SSSES UNIT 2 TECHNICAL SPECIFICATIONS CHANGES

FROM SSES UNIT 2 OPERATING LICENSE NO. NPF-22

Figure 3.4.1.1.1-1  
THERMAL POWER STABILITY RESTRICTIONS

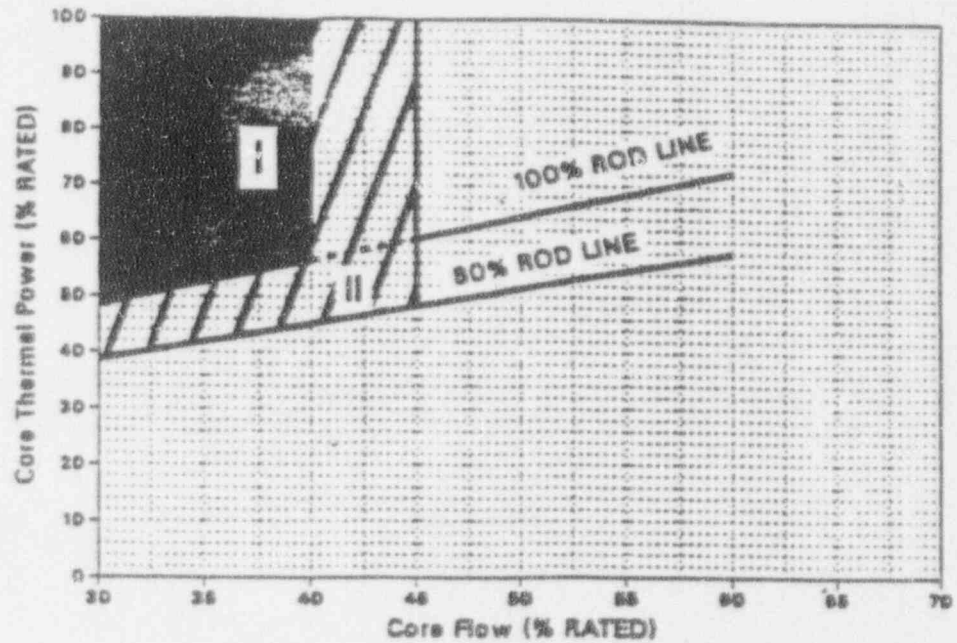
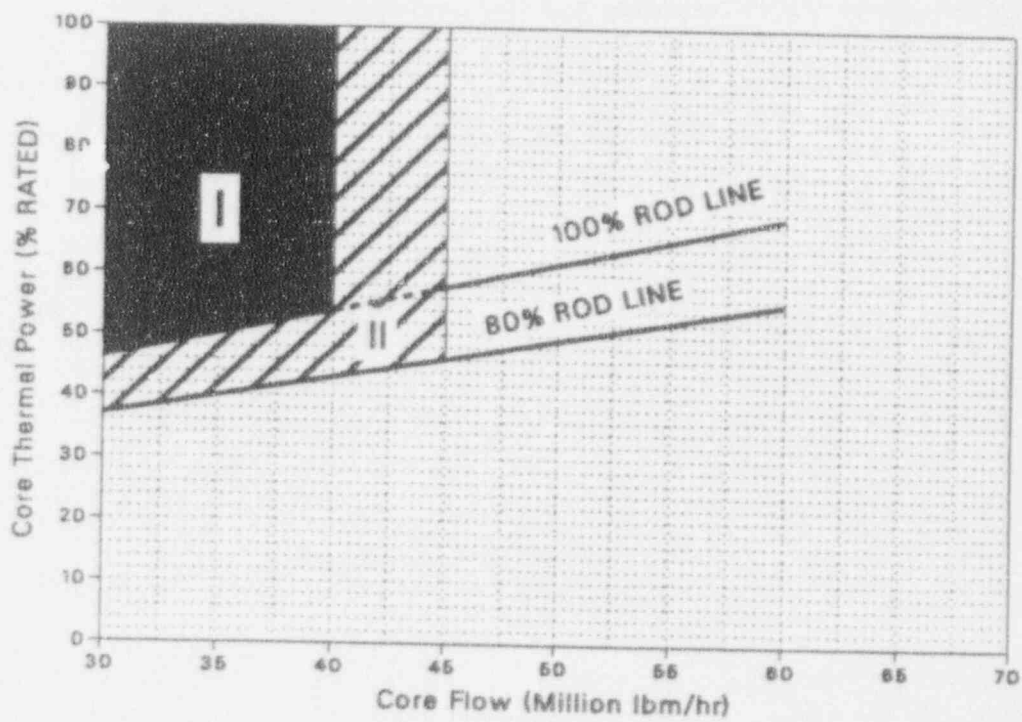
REPLACE WITH New Figure  
(ATTACHED)
